Subject: Response to Request for Additional Information Regarding License Amendment
Application for Measurement Uncertainty Recapture Power Uprate
(License Amendment Request No. 05-0007) (TAC No. MD5240)

RESPONSE TO REQUEST FOR ADDITIONAL INFORMATION

DAVIS-BESSE NUCLEAR POWER STATION, UNIT NO. 1

- 24. SRXB: If an LEFM becomes inoperative, you plan to rely upon venturis for a short time that have been calibrated with the last valid LEFM data. If a venturi defouling event should occur during this time, an overpower condition could result. Please discuss this possibility.**

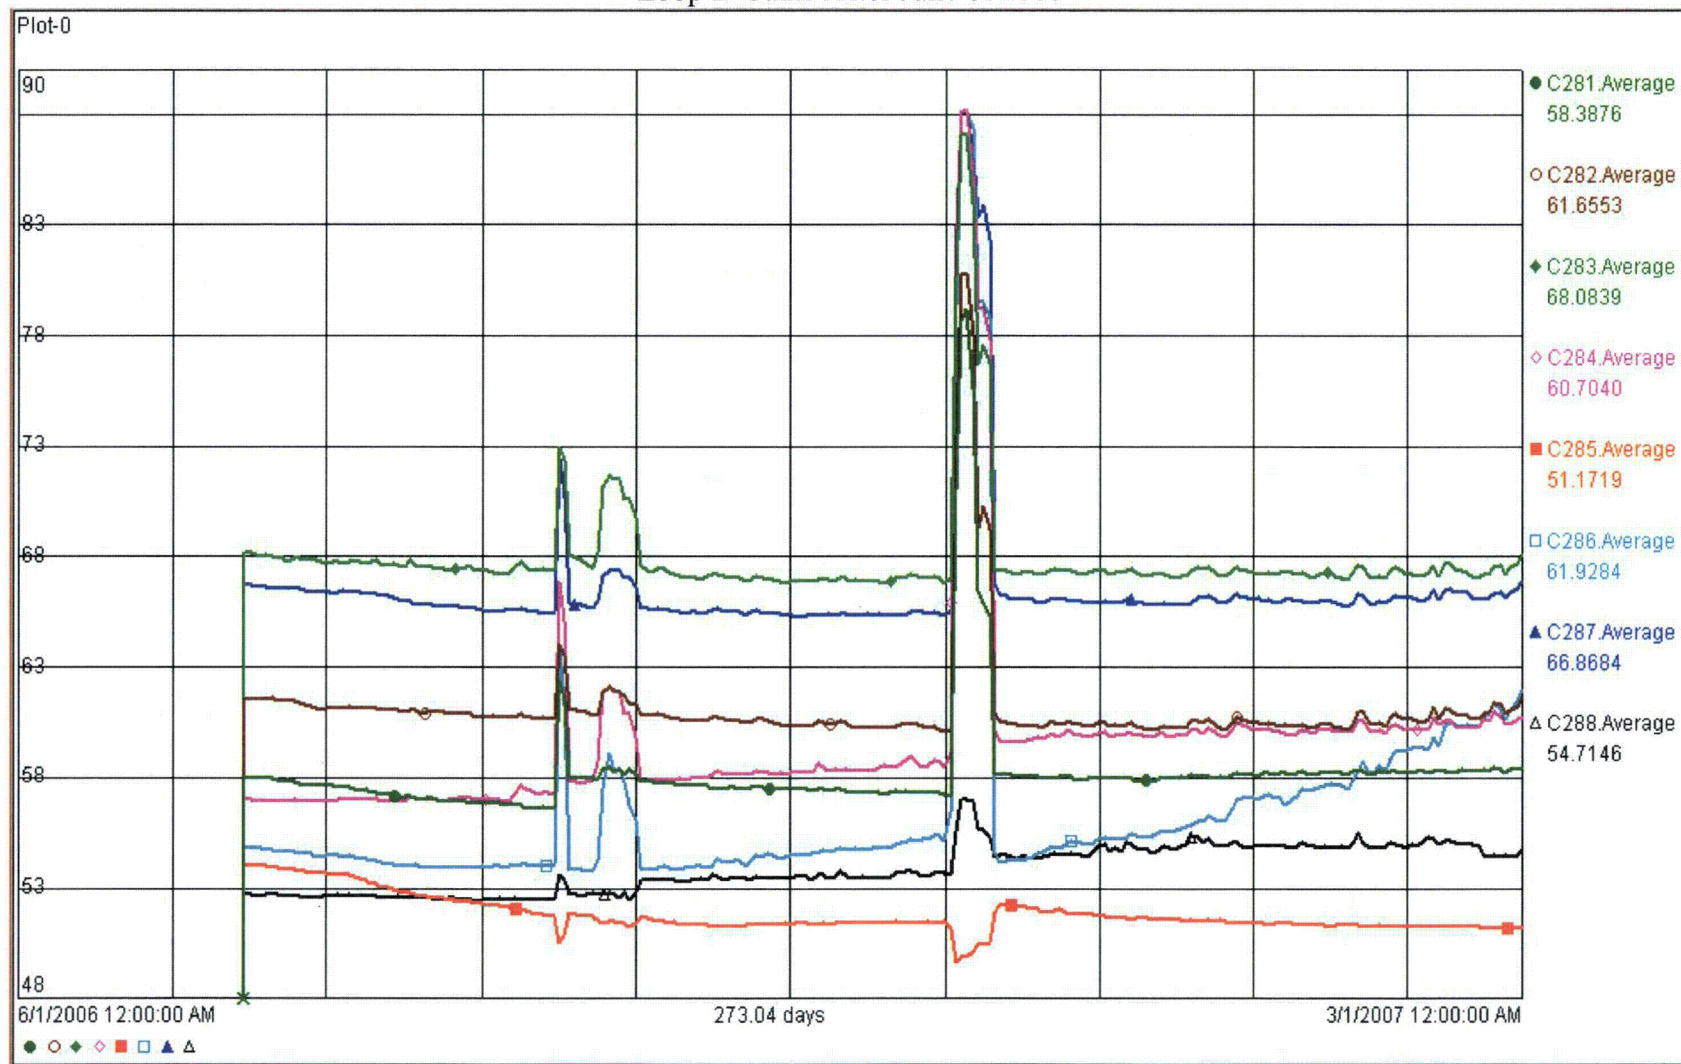
- 23. SRXB: Please provide a summary of LEFM characteristics before and after replacement of the 32 transducers in June 2006. This summary should contain a comparison to other feedwater measurement instruments over a sufficient time span to enable a valid comparison of before and after characteristics.**

- Feedwater temperature output of the LEFM and RTD prior to and after June of 2006.
- Pathway gains prior to and after June of 2006.

A review of the data for Feedwater (FW) temperature, which is one of the inputs to the heat balance calculation, shows consistency in trending between computer point C224 (LEFM FW temperature) and computer point T670 (RTD FW temperature) before and after June of 2006. The trends in LEFM FW temperature show no changes in the performance before or after the change out of the transducers in June of 2006. The downward spike in data for the graph of FW temperature prior to June of 2006 was due to the 14th Refueling Outage (14RFO). The downward spikes in the data for the graph of FW temperature after June of 2006 were due to plant maintenance outages or maintenance on the LEFM.

In summary, there were no identifiable effects observed in the data due to changing out of the transducers in June of 2006. Data was collected on the performance of the transducers after the change out and verified by Cameron that the LEFMs were performing within specifications.
